LETTER TRANSMITTING U S NAVY RESPONSES TO U S EPA REGION I, RHODE ISLAND  
DEPARTMENT OF ENVIRONMENTAL MANAGEMENT, U S FISH AND WILDLIFE AND  
NATIONAL OCEANIC AND ATMOSPHERIC ADMINISTRATION COMMENTS ON DRAFT  
SAMPLING AND ANALYSIS PLAN FOR CARR POINT WITH ATT

**DATE:** February 22, 2013  
**TO:** Distribution Listed Below  
**FROM:** Resolution Consultants  
**RE:** Response to Comments on Draft Sampling and Analysis Plan (SAP)  
Carr Point, NAVSTA Newport, Rhode Island

**NAVY RESPONSES TO  
U. S. ENVIRONMENTAL PROTECTION AGENCY (EPA)  
COMMENTS DATED DECEMBER 20, 2012  
ON THE DRAFT SAMPLING AND ANALYSIS PLAN,  
FORMER CARR POINT SHOOTING RANGE (MRP SITE 1, OU9) AND  
FORMER CARR POINT STORAGE AREA (IR SITE 22, OU10),  
NAVAL STATION (NAVSTA), NEWPORT, RHODE ISLAND  
(NOVEMBER 5, 2012)**

**FIGURE 3  
 PROPOSED SOIL SAMPLE  
 LOCATIONS**

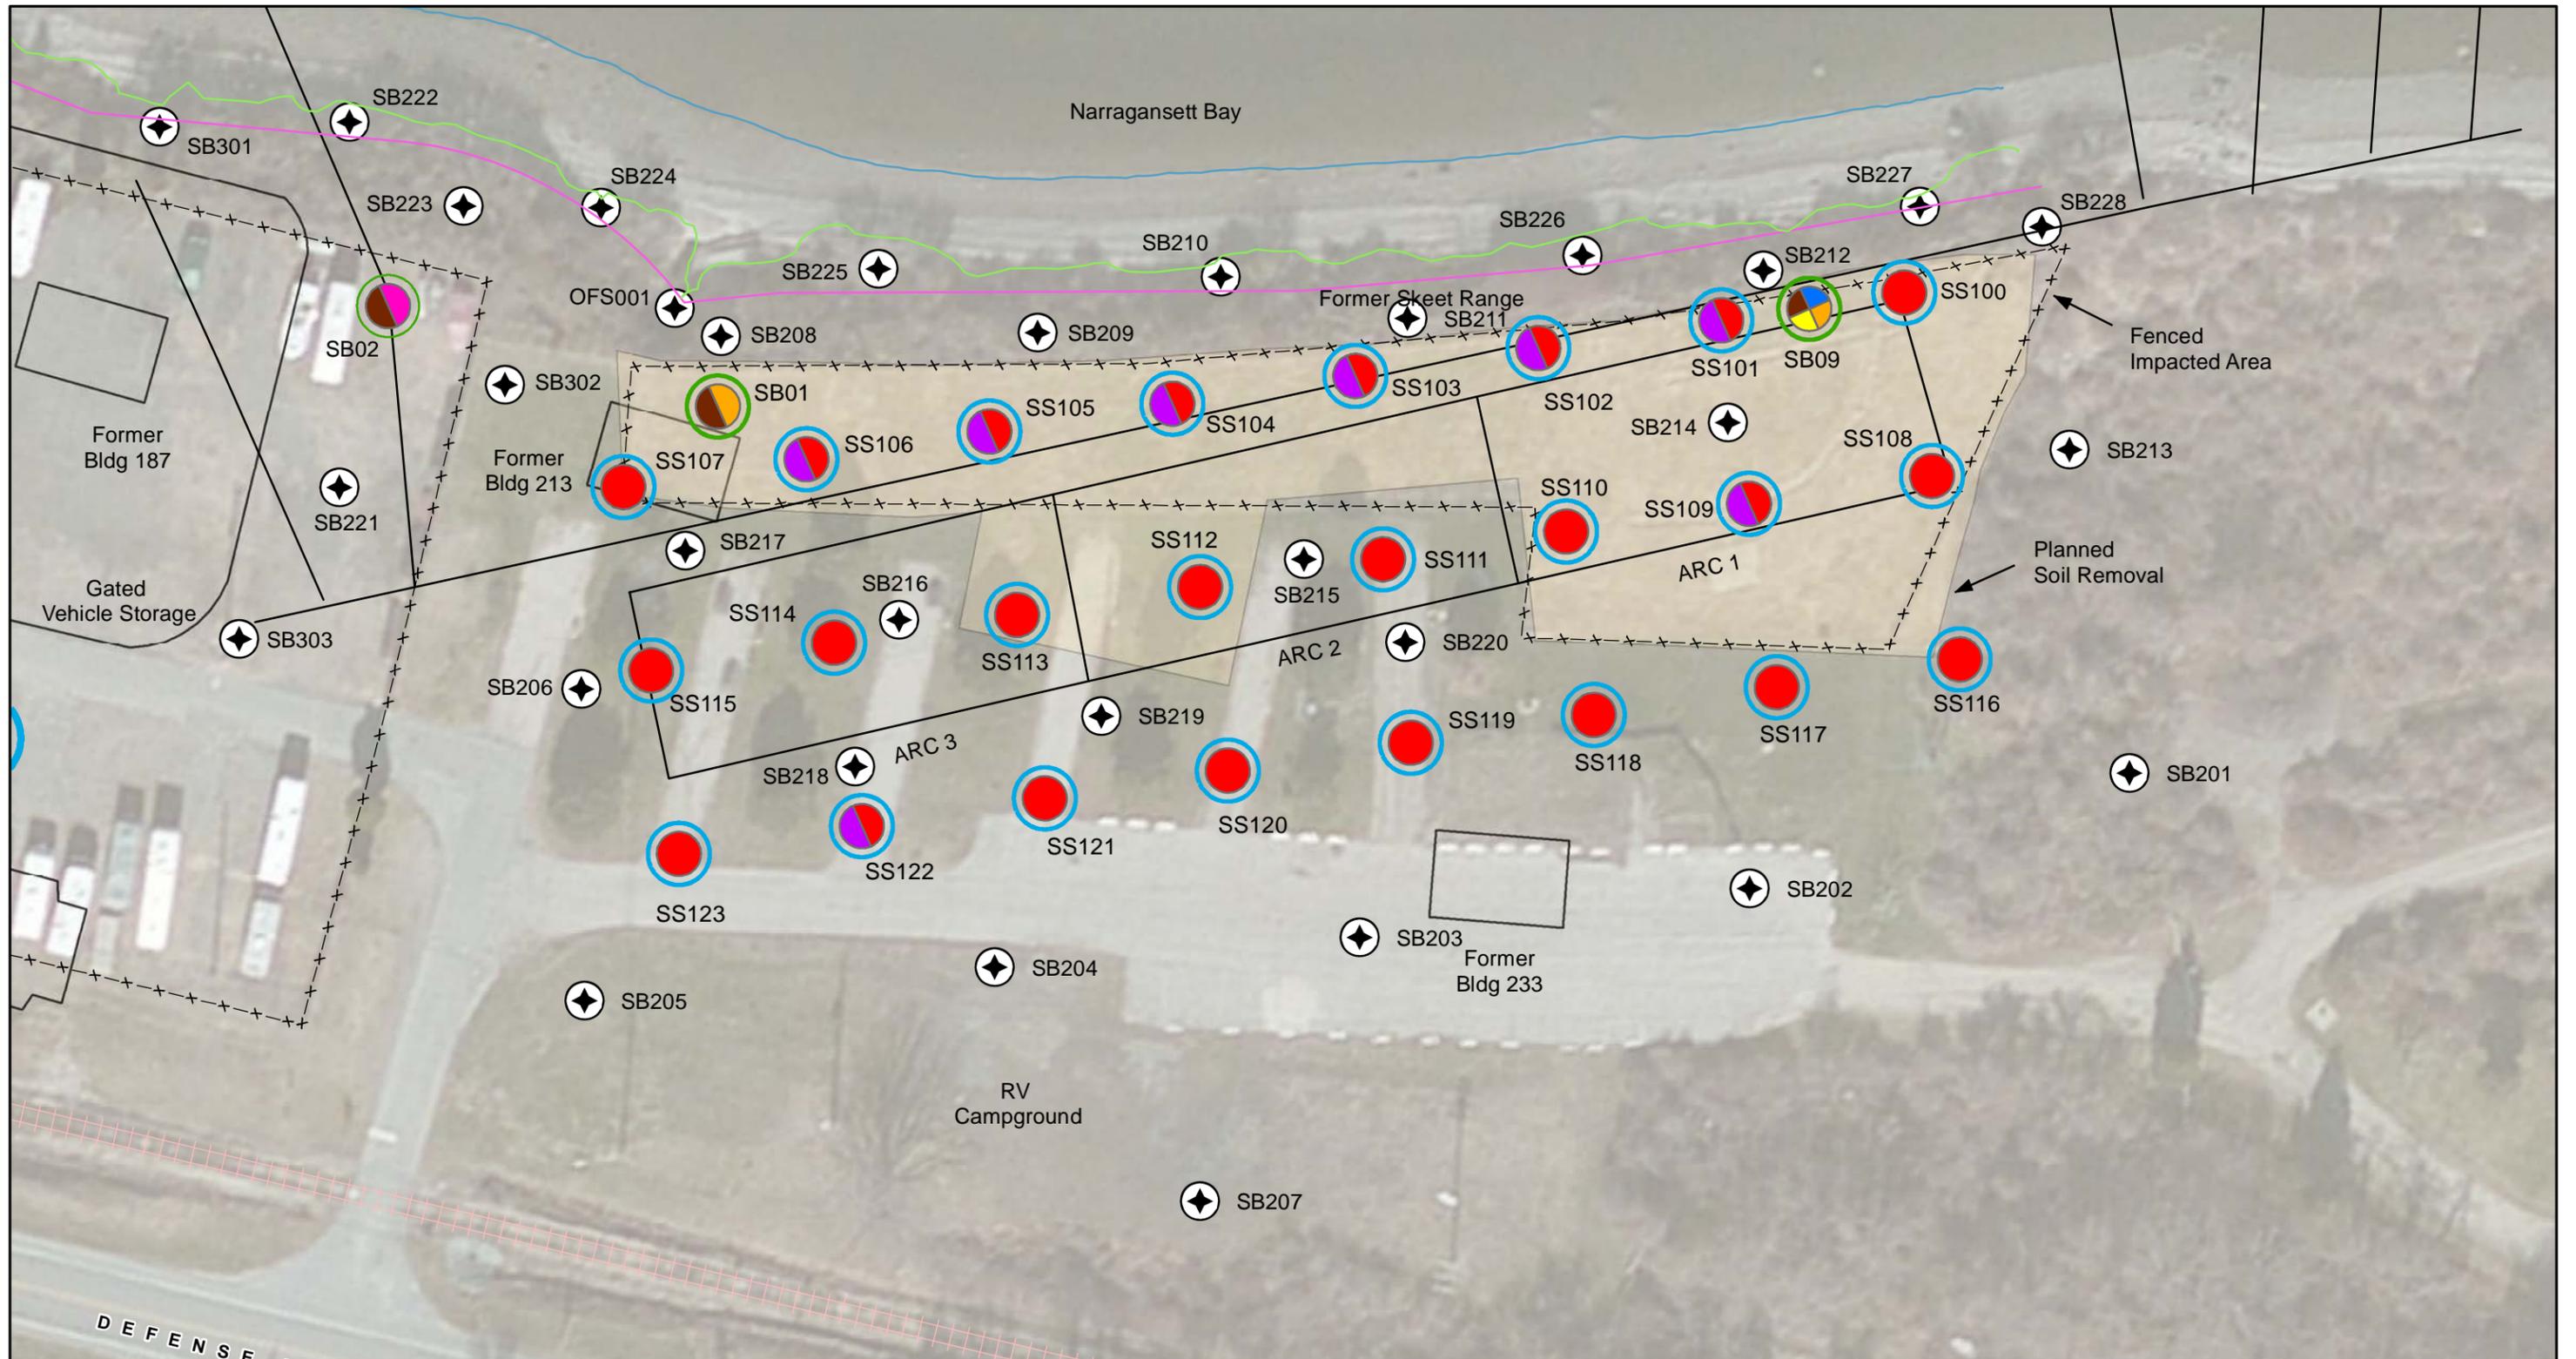
*Specific Comment 4: SAP Worksheet #10-1: Operational History: Anecdotal evidence of a third firing arc, along with SI exceedances, suggests that Pb pellets should exist within "20 degrees to the left of the southernmost range" which is under-represented in onshore and offshore sampling locations. In general, soil samples should be taken in transects with nodes not more than 50 feet apart along the proposed SB208 line, extending beyond the southernmost and northernmost 20 degree arcs, as described. Sampling should also be similarly conducted in the supratidal zone.*

**Specific Comment 34: Figure 3 and Figure 8:** *Please update this SAP to include additional soil sampling locations in the southern “Target Area” of the “Firing Fan”, southwest of proposed sediment sample SD124, east of samples SD103 and SD102 and northeast of proposed soil boring SB301 (shown on Figure 8). This area is shown on Figure 5 as within the Target Area, but has not previously been characterized.*

**Response:** The proposed soil sampling locations were revised during our 1/16/2013 meeting. The revised SAP will reflect the increased soil sampling locations. Please see attached figure (Figure 3) for the proposed soil sampling locations.

**FIGURE 4**  
**PROPOSED GROUNDWATER**  
**SAMPLE LOCATIONS**

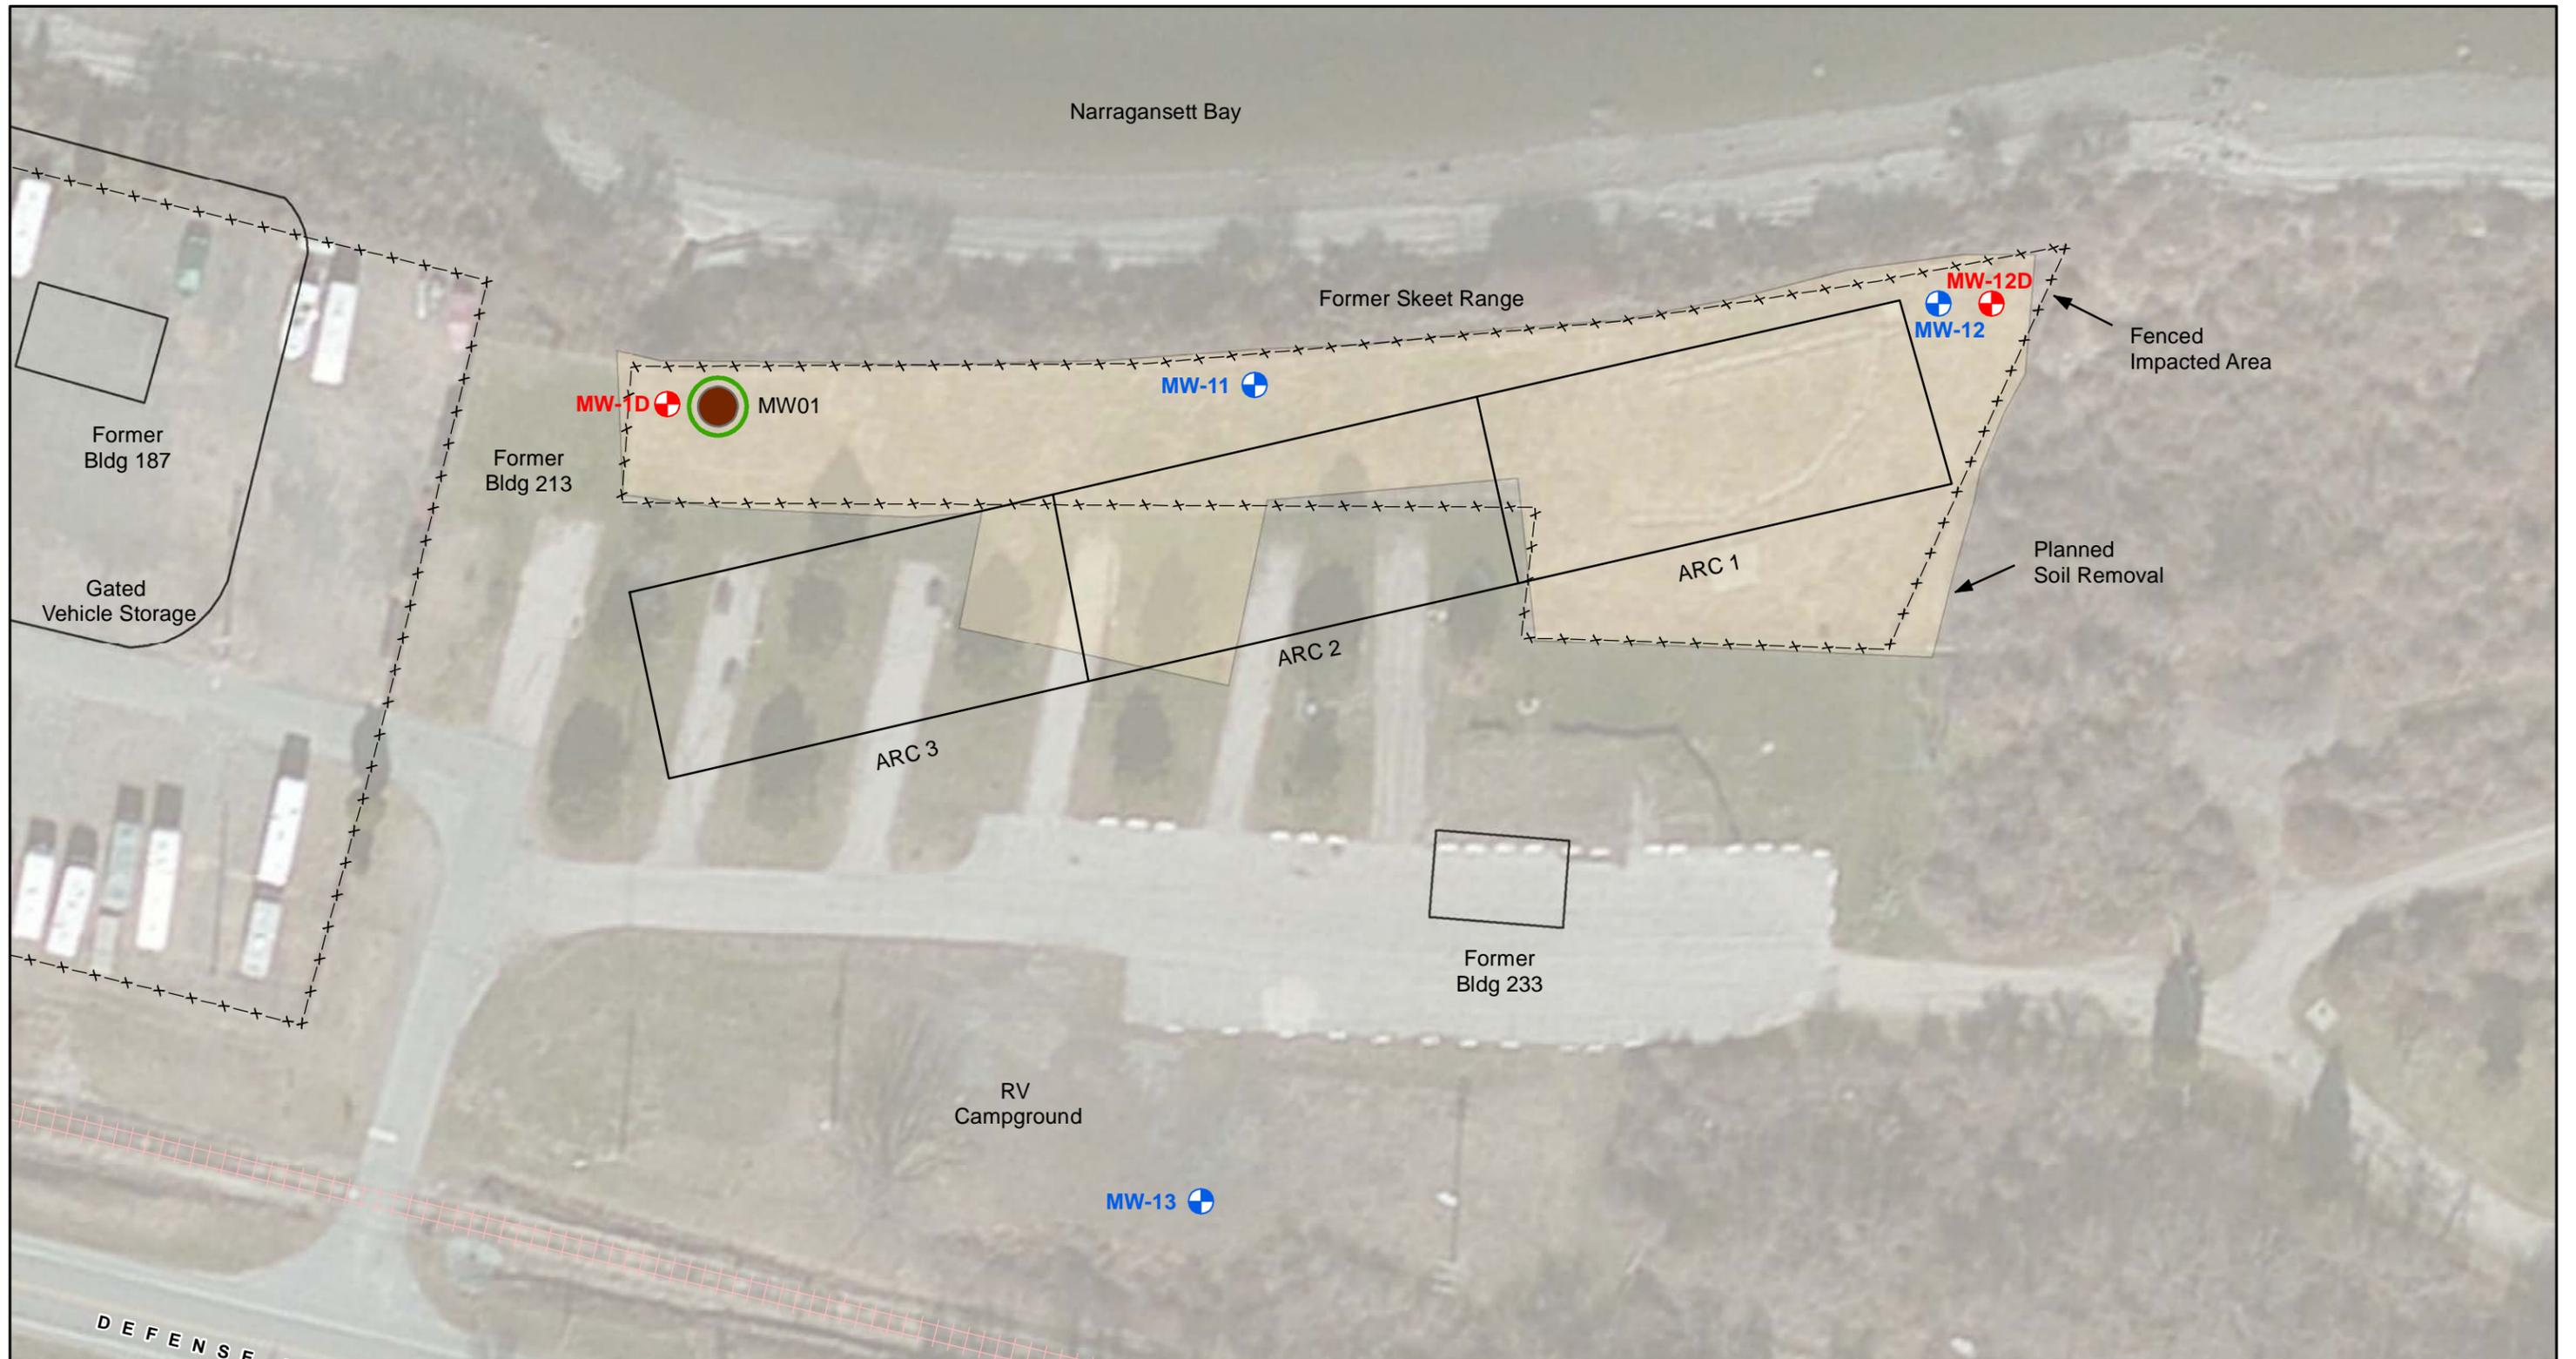
**Specific Comment 16: p. 74 (MRP Site 1) and p. 88 (IR Site 22), Groundwater Sampling:** *Because hydraulic flow direction has yet to be determined, a true upgradient groundwater monitoring well location will be uncertain at each site. Please install additional monitoring wells at the southwest and northeast boundaries and center of the MRP Site 1 and at the south boundary of IR Site 22. These additional wells would also help identify possible off-site migration. This comment also applies to Figures 4 and 9.*

**FIGURE 5**  
**PROPOSED NEAR-SHORE SEDIMENT**  
**SAMPLE LOCATIONS**

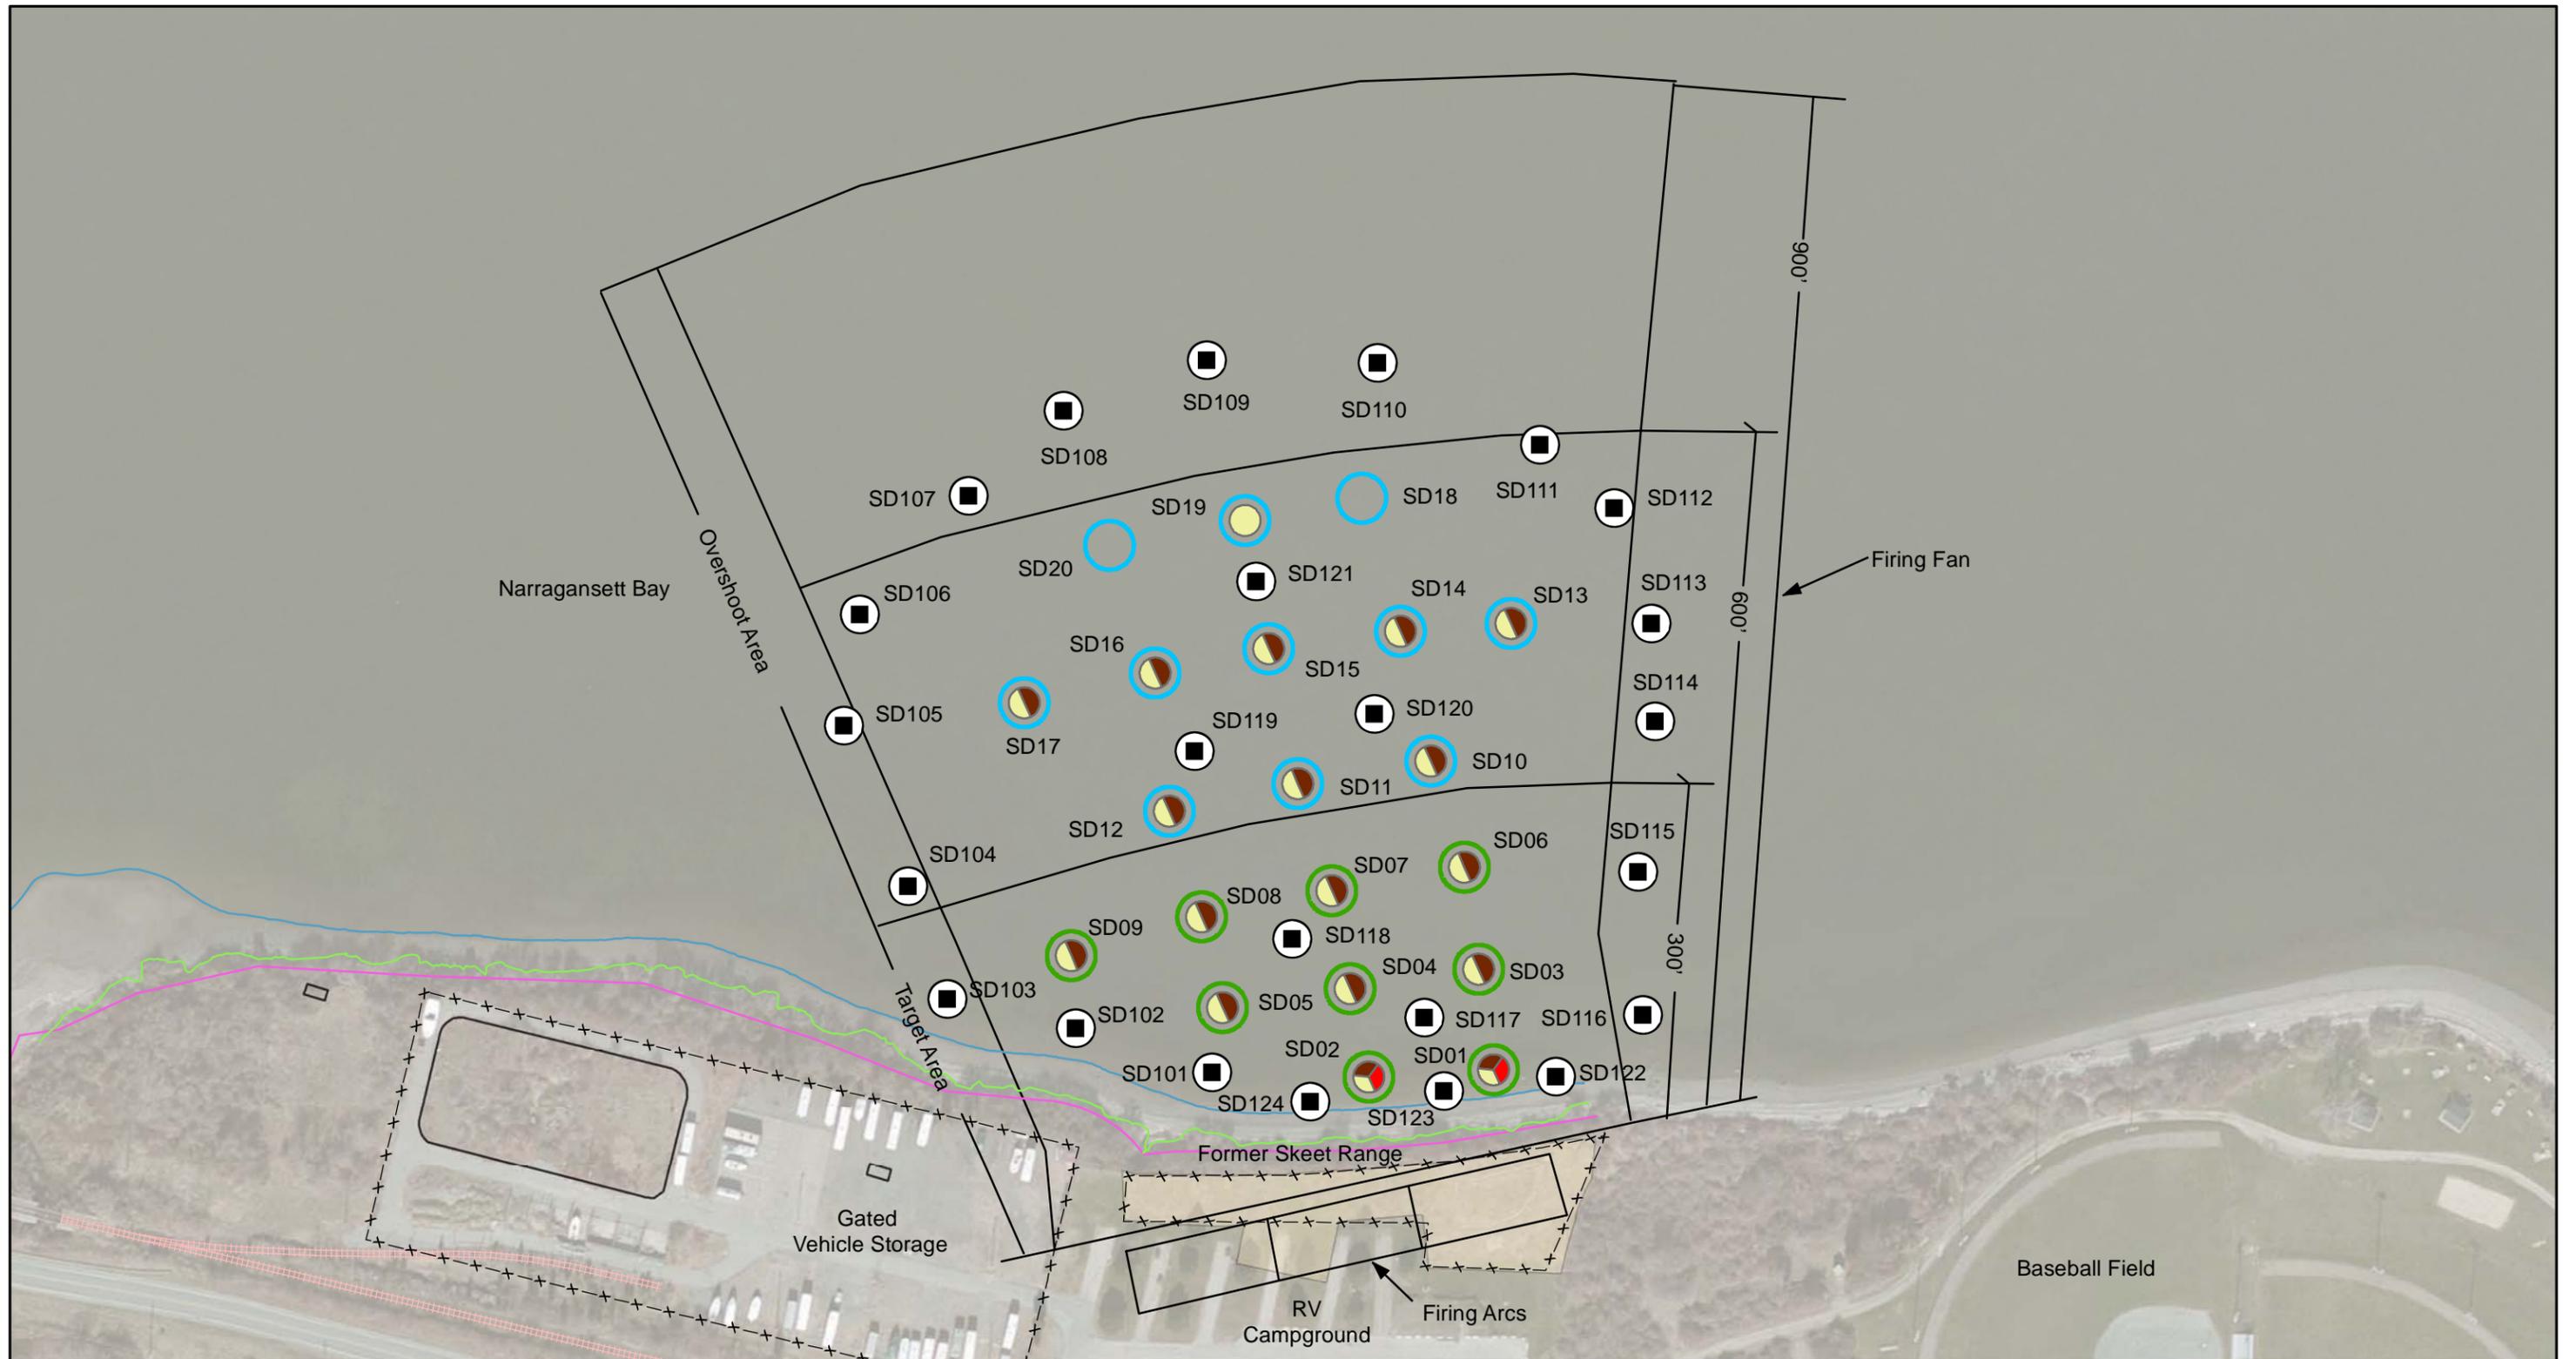
***Specific Comment 12: SAP Worksheet #11-1: Sediment Sampling:*** *Sample locations, as depicted on Figure 5, should include all intertidal areas within the defined firing arc. Notably,*

*Specific Comment 1: p. 43 (MRP Site 1), Operational History: Does the size of the target area and overshoot area take into account contaminant transport via tidal movement of sediment? It would seem that tidal action could potentially expand these areas. Please discuss this potential tidal influence in the document. This comment also applies to Figure 5.*

**Response:** As discussed and agreed to during the 1/16/2013 meeting, proposed soil sampling locations were revised to address potential impacts at MRP Site 1; however, it was decided that intertidal samples would not be collected due to the nature of the beach (i.e., present of cobbles). The revised SAP will reflect the increased soil sampling locations. Please refer to the attached figures (Figure 3 & 5) for soil and sediment sampling locations associated with MRP Site 1.

**Response:** As agreed during our meeting on to on 1/16/2013, please see the attached figure (Figure 5) for the proposed sampling locations.
